Subject: RE: NYM/2021/0220/FL - Boggle Hole Youth Hostel -

# Planning reference NYM\2021\0220\FL

YHA BOGGLE HOLE REFUSE STORE

PROPOSED PLAN & ELEVATIONS

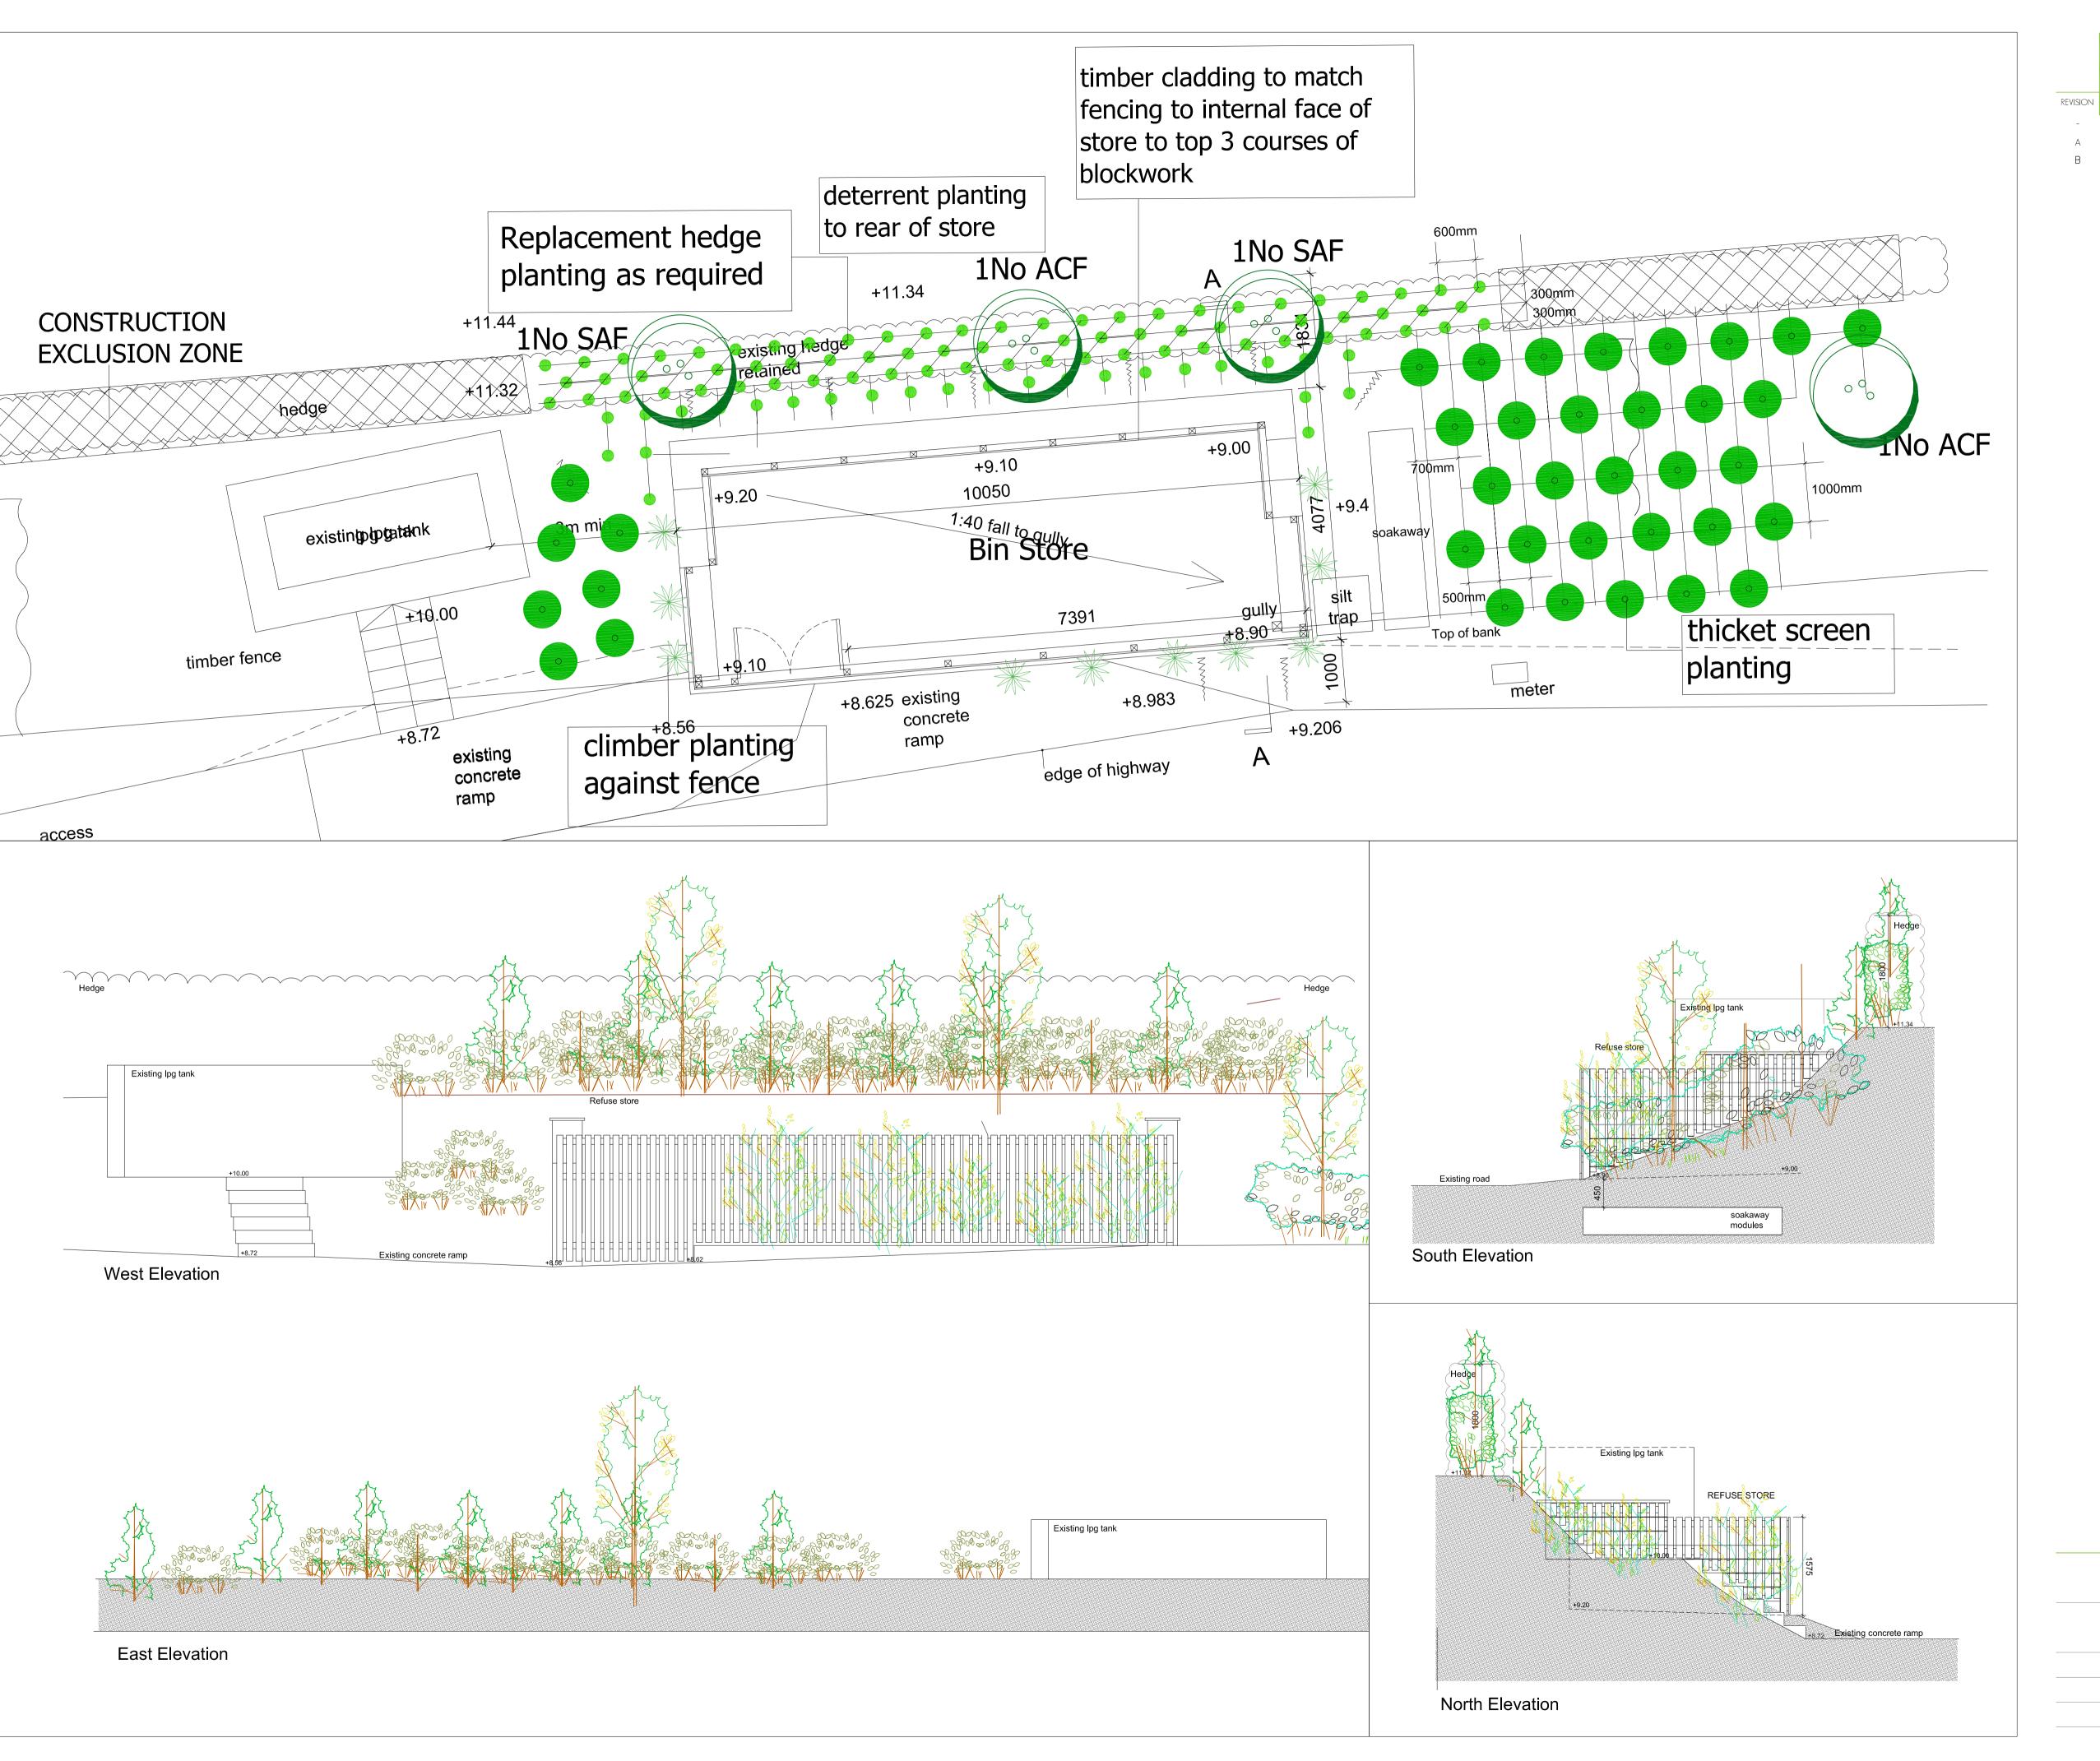
- 1. The front fence heights you have quoted and the submitted revised drawing show the front fence at the height of the existing front gates (they are quite tall in relation to height of the bins). The current structure has additional height of approx. 30cm (equivalent of one concrete block) oversailing the gates. Can you clarify that the 13 block high concrete walling and oversailing part of the fence will be reduced to 10 blocks high so as to coincide with the height and drawings and to be comparable with the existing gas compound closeby (there is no oversailing fence over the gates on that compound). The drawing shows the two compounds to be of comparable height at the front elevation.

- 2. Members were adamant that they wanted climbing plants planted in front of the front fence as shown on all the approved drawings. I do not think the proposed idea of training plants from the side will be acceptable to the Authority, please will you reconsider this with a view to creating five breakout areas into the apron and adding soil if necessary to create more effective mitigation for this large structure.

The A-A cross section shows a maximum height of 1.9m, which I believe, means the back retaining wall will be removed down to a height of 1.85m.

The front elevation shows the fencing as almost parallel in height, showing the South side, right-hand end as 1.90m and the North side on the left-hand end as 1.8m.

Does this mean the existing 2.4m height at the North end is to be reduced down from the top to achieve the proposed height of 1.8m, or am I correct in assuming the existing top height point of the palings will not change , but the ground will be raised towards the North end to reduce the length of the palings? This is a drafting error that has now been corrected on the west elevation, the ground level was shown correctly but the base of the fence was not amended, the corrected drawing is now attached.

The Plan view shows the Gates in the existing position with the climbing plants in front of them! yet the front elevation shows the gates in a proposed more central position. Would you explain which drawing is correct please?

The Apron identified as tarmac, is concrete at the moment, even though the original Planning Permission stated the Apron should be Tarmac.

The screening plants, identified at the Planning committee meeting as climbing plants due the small amount of space to grow anything was to be planted where there is now concrete. Am I correct in thinking the concrete will have holes made in it to enable plants to be planted? The climbing plants will be planted to the sides of the enclosure and trained to grow around the front, as it is not thought that the ground under the ramp will be good enough to sustain the plants.

- 1. The attached drawing show the fence to the front elevation amended to match the height of the gates. This level has been taken around to the side elevations as far as the first rise in the blockwork. We cannot remove an additional layer of blockwork all the way around the structure as the height of the retaining wall to the rear would mean that there are issues in relation to the ground level behind.

- 2. In regard to the proposal for planting to the front of the store there are serious concerns about the viability of any planting in this location. This area is within the highway, as shown on the attached plan that we obtained for the original application, showing that the highway extends up the track ramp. In addition there is the concern that any soil in this location, considering the slope would be prone to being washed out when there is any significant rainfall, making any planting here unviable.

Please can you confirm this is correct? Yes, the back wall will be lowered to meet the height of the front wall.

Can you confirm, that this time the Apron will be Tarmacked as the Plan states? The gate position on the elevation had now been corrected to match the plans. The original plan was to put a new apron in as it was thought that the concrete ramp would have to be broken out, however more of the existing was able to be retained so it was not necessary to replace the existing concrete ramp.

18.03.21 RCO A Base of fence corrected on west elevation 13.05.21 RCO B Front section of fence lowered
